Water Reduction Program Agreement Between the Sacramento River Settlement  
Contractors Nonprofit Mutual Benefit Corporation, Individual Sacramento River  
Settlement Contractors, and the U.S. Bureau of Reclamation Project

# Final Environmental Impact Report

Prepared for Glenn-Colusa Irrigation District

**Figure 1. Subsidence in Agricultural Lands Within the Colusa Subbasin (AquAlliance)**

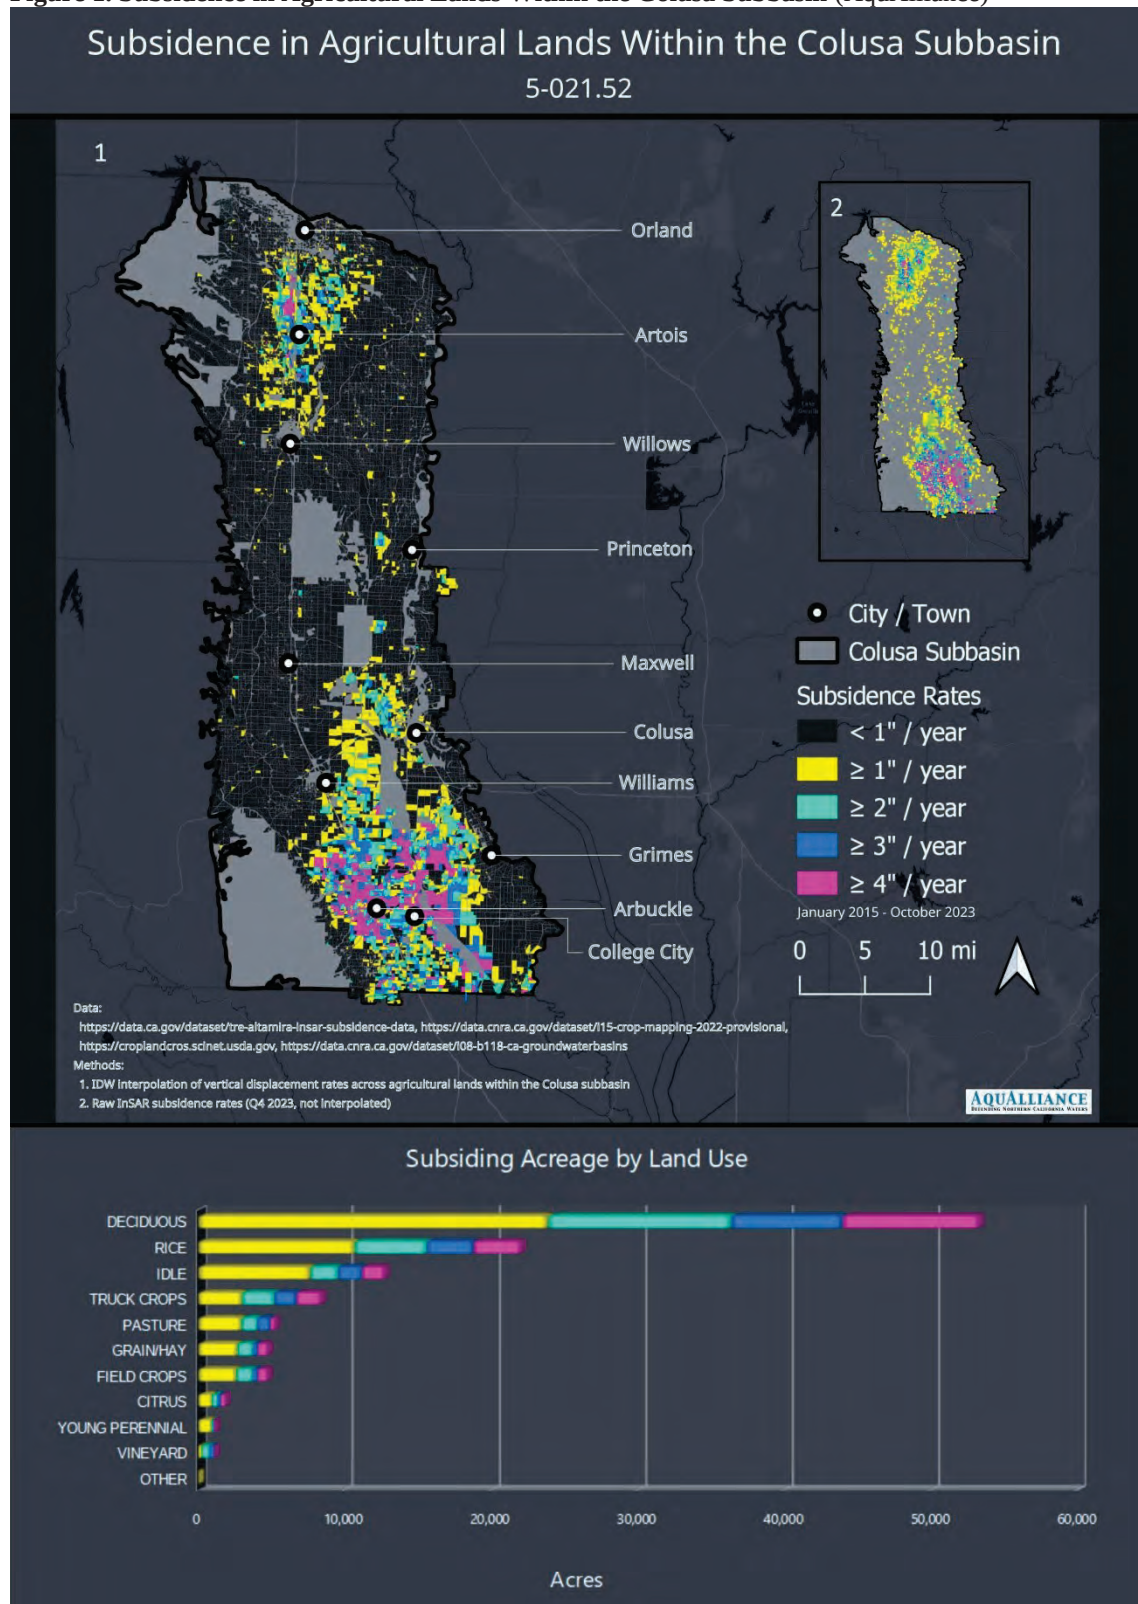
b) Figure 2 clearly illustrates the subsidence in the Colusa Subbasin. How does it compare with the GSP material? As one can see in the magenta areas, the land is collapsing at 4 inches per year, or a foot every three years. Knowing the land uses overlying the subsidence paints an interesting picture. What will the GSAs consider doing to stop the actors causing it?

**Figure 1. Subsidence in Agricultural Lands Within the Colusa Subbasin**

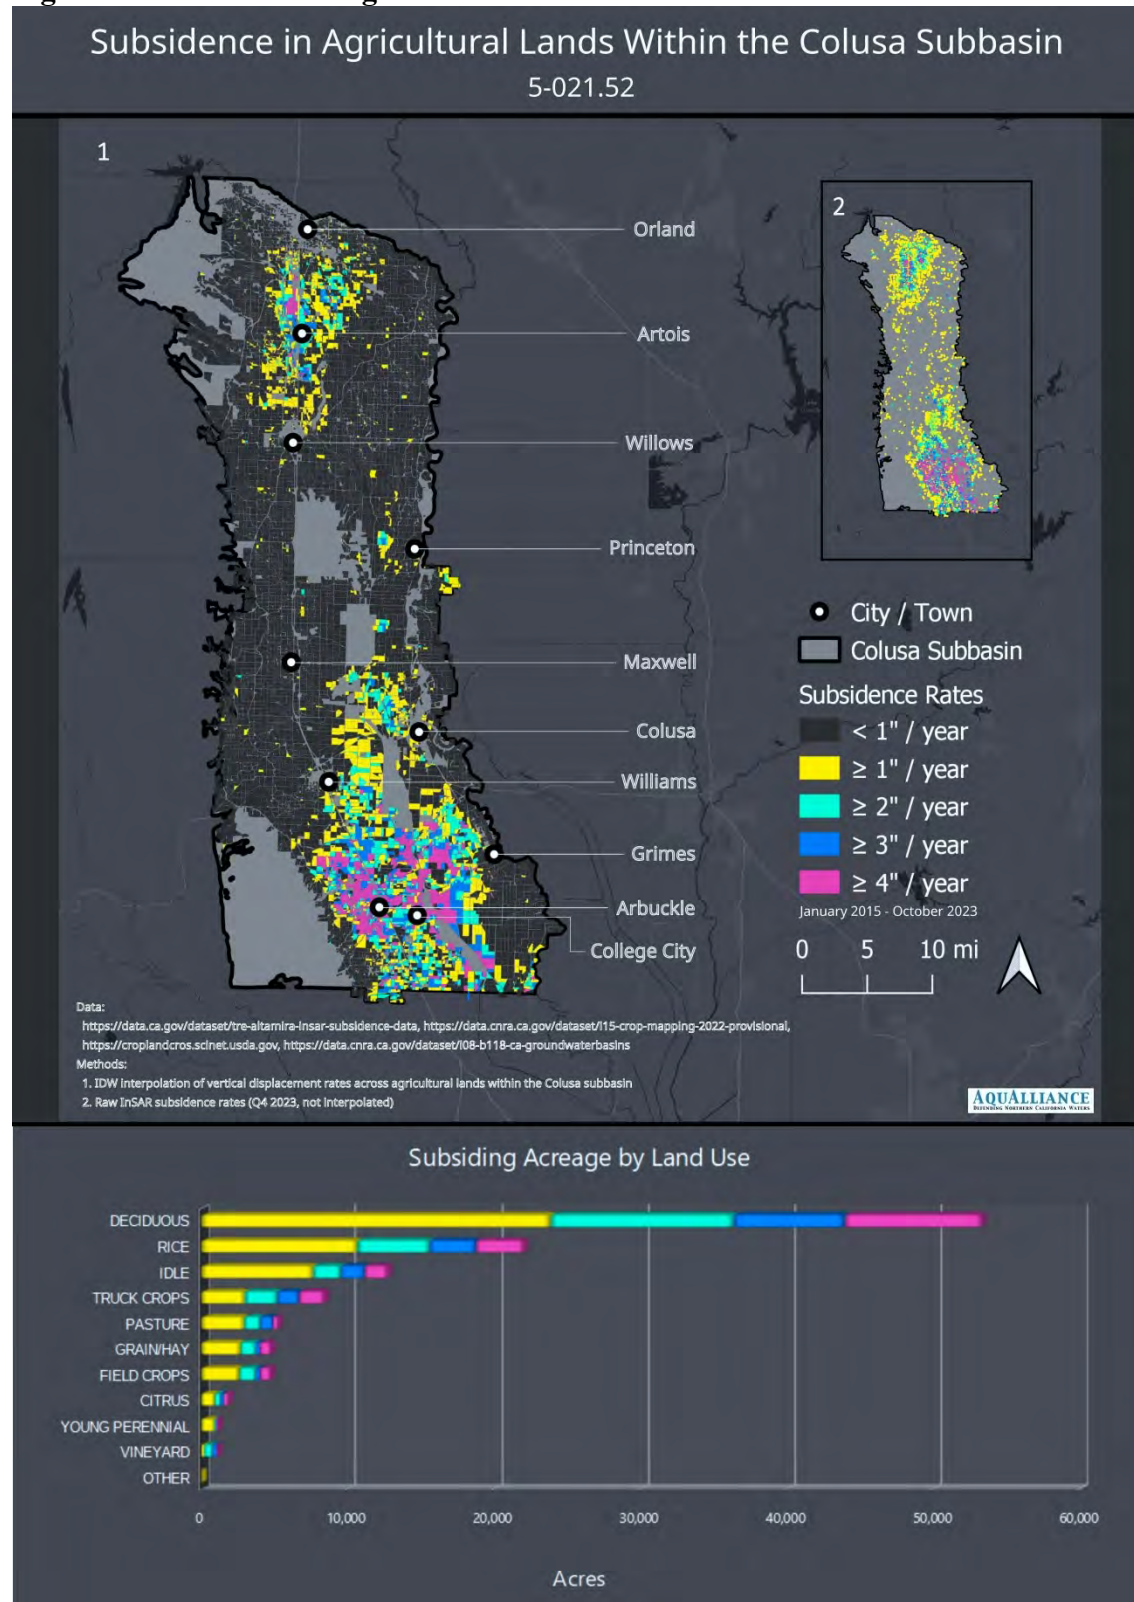
b) Figure 1 clearly illustrates the subsidence in the Colusa Subbasin. How does it compare with the GSP material? As one can see in the magenta areas, the land is collapsing at 4 inches per year, or a foot every three years. Knowing the land uses overlying the subsidence paints an interesting picture. What will the GSAs consider doing to stop the actors causing it?

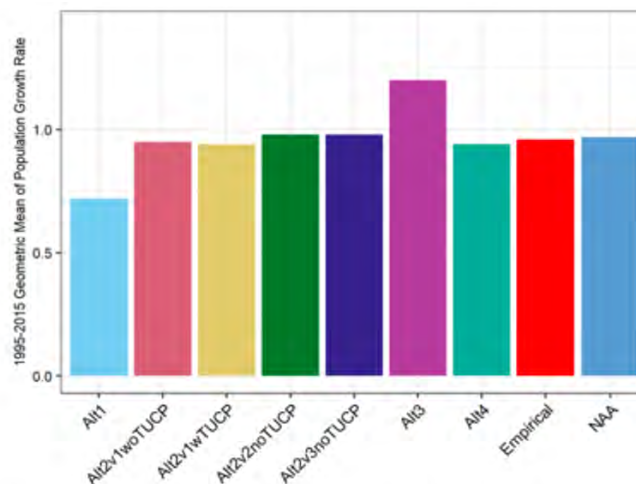
The Delta Smelt LCM analysis clearly demonstrates that Alternative 3 substantially outperforms all other alternatives with respect to estimated future population growth rates (DEIS, Figure 1; Attachment F.4, Table F.4-5 and Figure F.4-9). In fact, Alternative 3 is the only alternative that produces positive Delta Smelt population growth rates on average. Negative average population growth rates shown in all other alternatives are consistent with inviable populations and extinction (McElhaney et al. 2002). Alternative 2 variants produce negative growth rates that are, on average, nearly indistinguishable from or worse than the NAA and empirical growth rates that have led to the near disappearance of this once abundant endemic fish species. Furthermore, all Alternative 2 variants perform worse than NAA or empirical results in Wet and Above Normal Years. The DEIS provides some insight into this result, explaining:

This demonstrates that Alternative 2 is not consistent with requirements of the ESA (especially given that Alternative 3 and non-alternative scenarios (“EXP1” and “EXP3”) demonstrate that operations that result in positive population growth are possible). Alternative 1 performs far worse than the NAA (Figure 1 below; *see also* DEIS, Attachment F.4 at Table F.4-5).

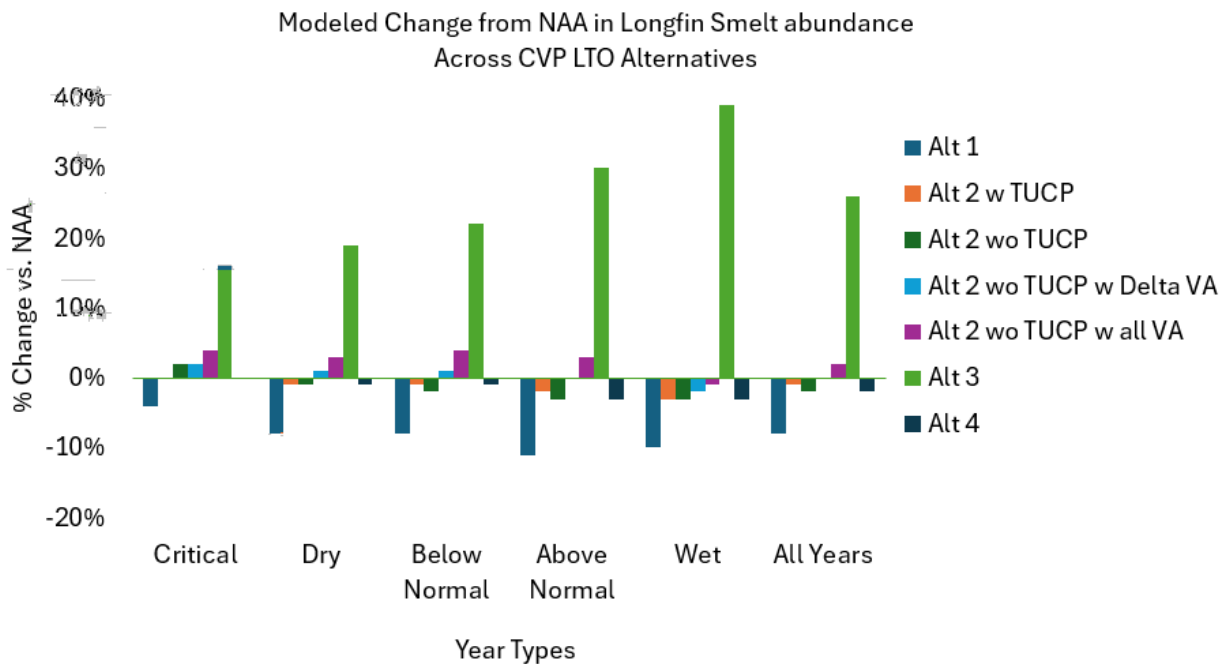
Moreover, a proper comparison of alternatives (i.e., comparing the *differences* in predicted annual Longfin Smelt abundance indices among alternatives) shows that the relative performance of different alternatives is very consistent. The fact that the Longfin Smelt population displays high variance (and that the 3-4 order of magnitude decline over time adds to this variance) does not mean that there is any uncertainty regarding the relative performance of Alternative 3 as compared to NAA. Notwithstanding the DEIS's statistically inappropriate efforts to minimize the different effects of the alternatives by comparing them to the variance within alternatives (e.g., as in DEIS Appendix AB-J attachment J, Figure J.1-2), Alternative 3 is superior to the NAA in *every year* modeled (Figure 3). The other alternatives are barely different

from the NAA during drier years (Figure 2) and when the estimated population is low (Figure 3), and their performance decreases relative to NAA as conditions become wetter and/or as the estimated annual population index increases. Under the NAA and all alternatives other than Alternative 3, the Bay-Delta Longfin Smelt population is likely to continue to decline to extirpation in the near future. Such an outcome is inconsistent with the requirements of both state and federal Endangered Species Acts.

Figure 4: Coho Salmon egg survival and Trinity River hatchery water temperatures, 2021 (Clifford 2022). Copied from Memorandum to SWRCB, From: Justin Ly, April 27, 2022, re: Comments on Reclamation's draft Sac River Temperature Management Plan. Accessed at:

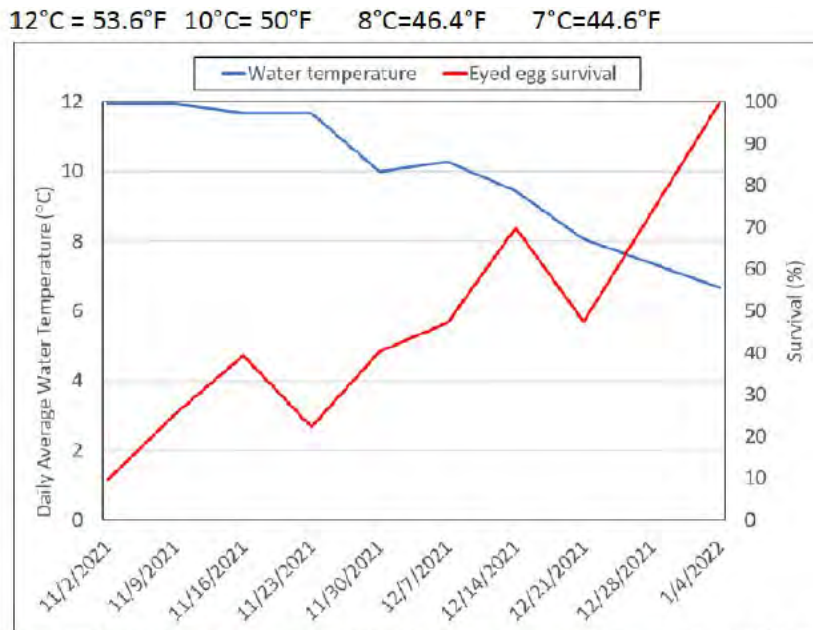
River hatchery were impacted by temperatures well below 56°F, but greater than 50°F (Figure 4).

Figure G3a-72. Trinity Reservoir End of April and End of September Storage (TAF) Percent Exceedance Plot

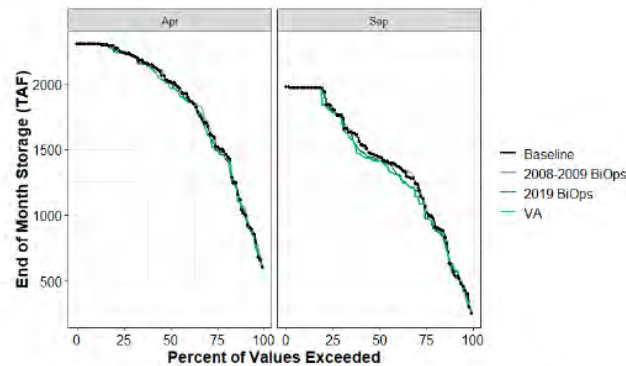
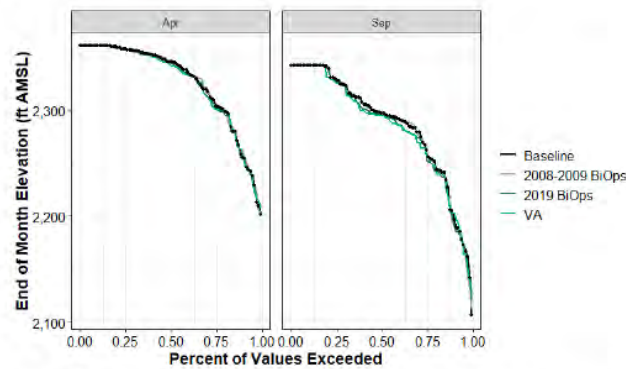
This impact is significant because coldwater storage in Trinity Lake is already impaired due to excessive water deliveries and climate change. **Mitigation for the Proposed Project's temperature impacts on Trinity Lake is required until completion of the separate Trinity River BA, BO and SEIS.**

**Figure 4.4-56. Box Plot of Longfin Smelt April–May Salvage, from the Regression Including Mean Old and Middle River Flows (Grimaldo et al. 2009), Grouped by Water Year Type**

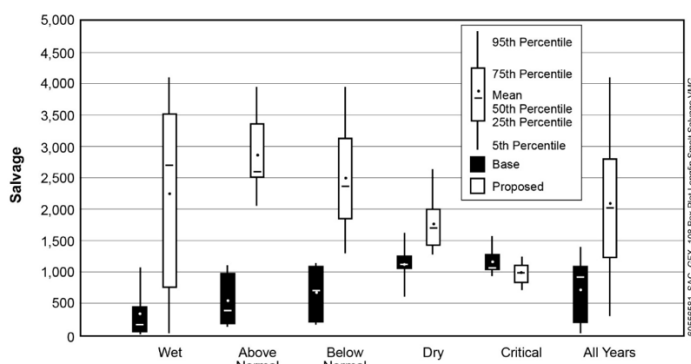
project operations, it must have a negative effect on overall abundance at some point. The DEIR projects very substantial increases – between 8% and 73.8%, depending on water year type – in salvage of juvenile Longfin Smelt from Proposed Project operations relative to the baseline (DEIR at Table 6-22 and Figure 6-52).

constrained by protections found in the 2008/2009 biological opinions (USFWS 2008; NMFS 2009). Recent research indicates that those constraints reduced entrainment impacts for Delta Smelt (Smith et al. 2021) and they are more likely than not to also have reduced entrainment for Longfin Smelt. However, those operating rules have now been replaced by operations analyzed in CDWR's 2019 DEIR (as revised). CDWR previously projected massive increases in Longfin Smelt juvenile entrainment resulting from current project operations when compared to the prior baseline (the 2008/2009 baseline; CDFW 2019 "Part III revisions to the DEIR" Table 4.4-13 and Figure 4.4-56 at 4-185; *see below*). Thus, juvenile salvage rates (CDFW 2019 Table 6-23) were expected to increase several-fold under current SWP operations. Under the Proposed Project, rates of entrainment-related mortality are expected to increase yet again.

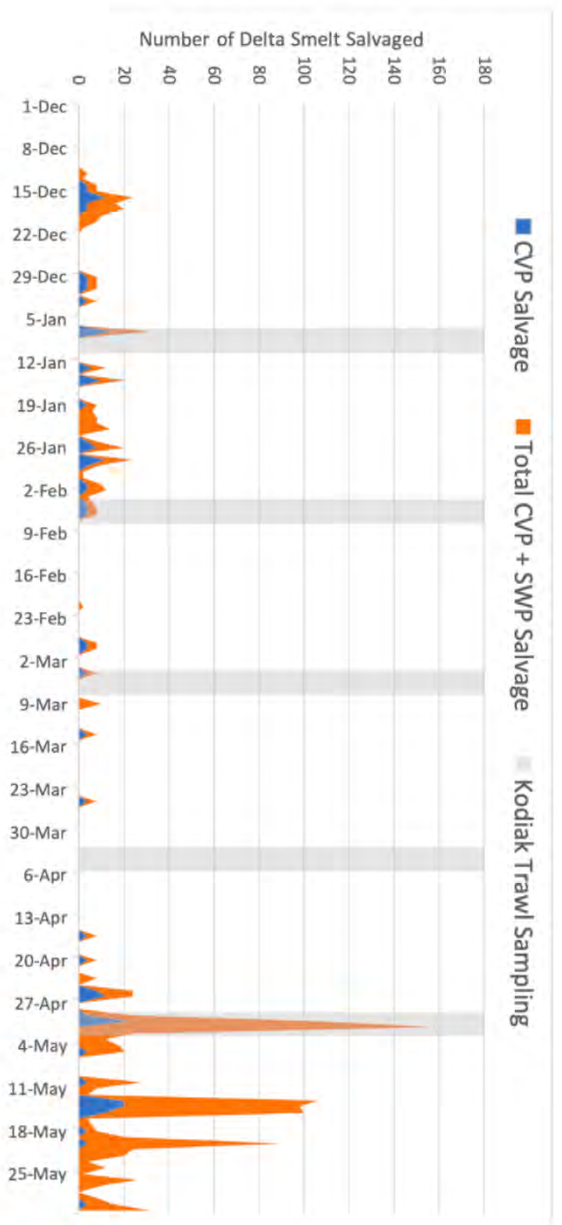
were salvaged (16, 11, 4, and 284 fish, respectively; Figure 1). This indicates that Longfin Smelt larvae and juveniles are susceptible to entrainment-mortality, even when sampling programs fail to detect them close to the export facilities.

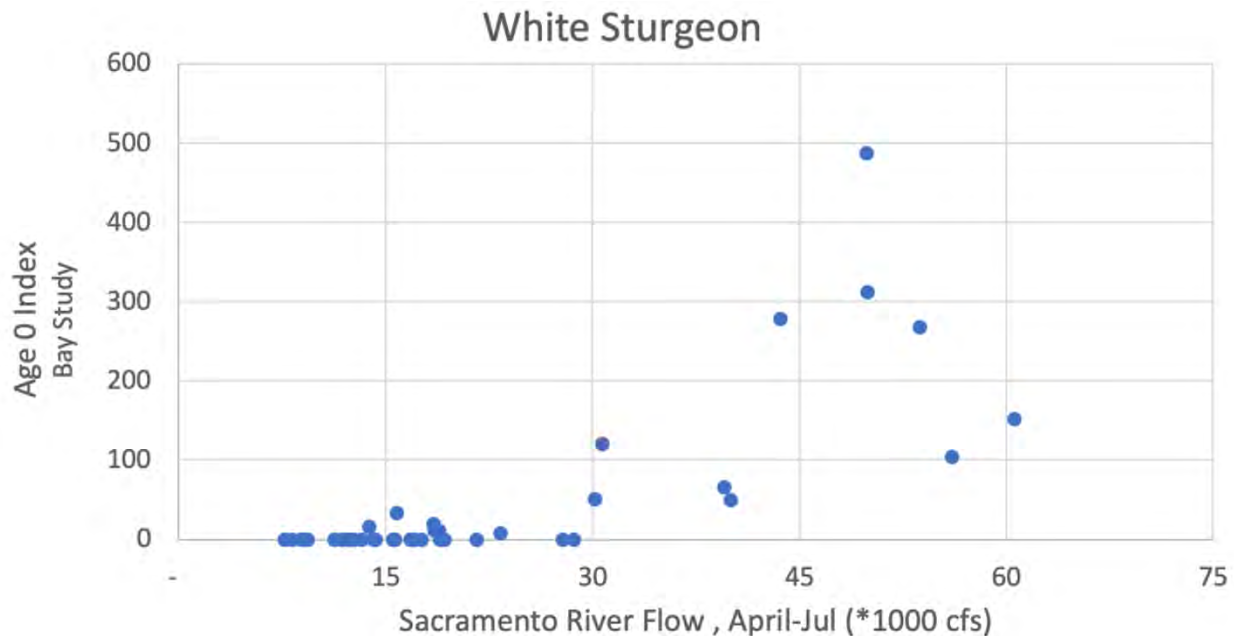
Furthermore, Baykeeper et al (2023) showed that recruitment of YOY White Sturgeon was very low or zero when Sacramento River flows (“SAC” + “YOLO” variables in Dayflow) average < 30,000 cfs between April and July (Figure 2).

Figure 3: Figure C-2 copied from Reclamation's Biological Assessment of Central Valley Project long-term operations; Appendix AB-C of Reclamation's DEIS for Central Valley Project long-term operations at p. 22 of the PDF.

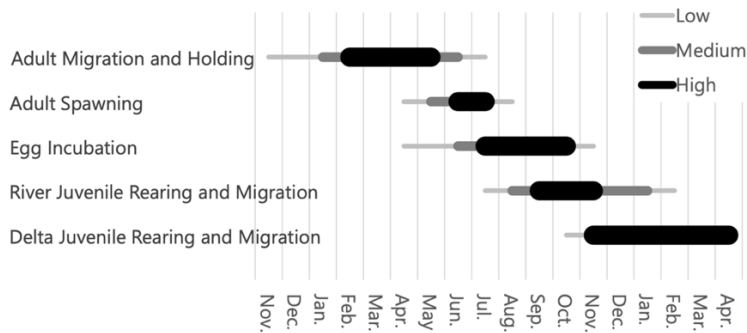
The relevant months for winter-run Chinook Salmon migration through and out of the Delta are October through April (Figure 3). The DEIR's application of the STARS model shows that winter-run Chinook Salmon through-Delta survival under the Proposed Project will be equal to or worse than the baseline in most years in October (Table 6-48 at 6-152), December (Table 6-50), and February (Table 6-52). Other months are projected to have survival rates that are less than or equal to the status quo in multiple water year types. In cases where analyses suggest the likelihood of increased survival relative to the status quo, such increases are tiny. As discussed above, it is very likely that river flows and Delta outflow will decrease and the negative effect of Delta hydrodynamics (e.g., increasingly negative OMR) will increase in years where project operations are governed by TUCO's and/or waivers/relaxed enforcement of ESA safeguards. Thus, expectations of through-Delta survival rates for winter-run Chinook Salmon are likely to be less positive in real life than they are in the DEIR's modeling.

The DEIR does not reveal that the project baseline was expected to result in lower through-Delta survival of winter-run migrating prior to December (CDWR 2019 at 5-163), a pattern that is potentially exacerbated under the Proposed Project. Nor does the DEIR disclose that baseline survival, which was previously estimated to range from below 20% in Critically Dry years to at best < 40% in Wet years (CDWR 2019 Figure 5.3-57 at 5-162), is well below the 57% survival that NMFS targets as the minimum necessary to recover this endangered salmon population<sup>35</sup>.

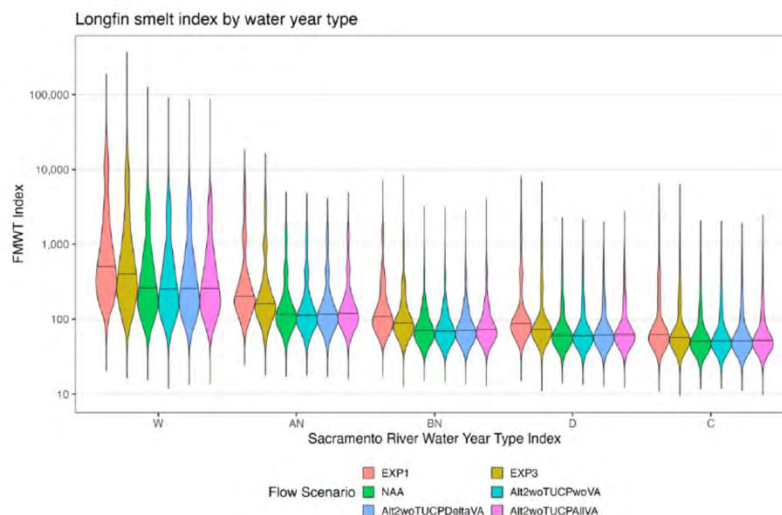
**We ask that the Service share with us the model and methods used to generate the figure below and to reconsider how it interprets the very large differences shown in that figure in predicted outcomes of different management alternatives.**

Figure 6-52. Exceedance Plot of Longfin Smelt April-May Salvage Prediction Interval, Based on the Analysis using the Salvage-Old and Middle River Flow Regression Developed by Grimaldo et al. (2009a)

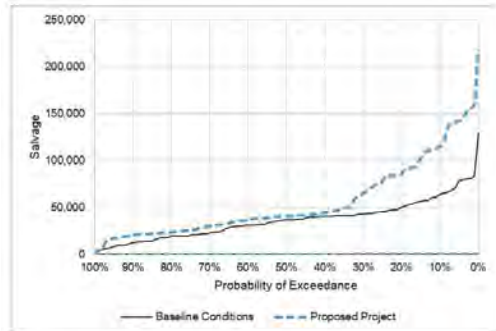
On top of these impacts (which are now the baseline for proposed reoperation of the CVP and SWP), even more negative OMR flows during April and May are expected to result from proposed CVP/SWP combined operations (SWP 2024 ITP DEIR at Figure 6-52, *see below*) and additional, very large increases in juvenile entrainment will result (SWP ITP DEIR at Table 6-22,

see below); larval entrainment during April and May should also be expected to increase under proposed CVP/SWP combined operations.
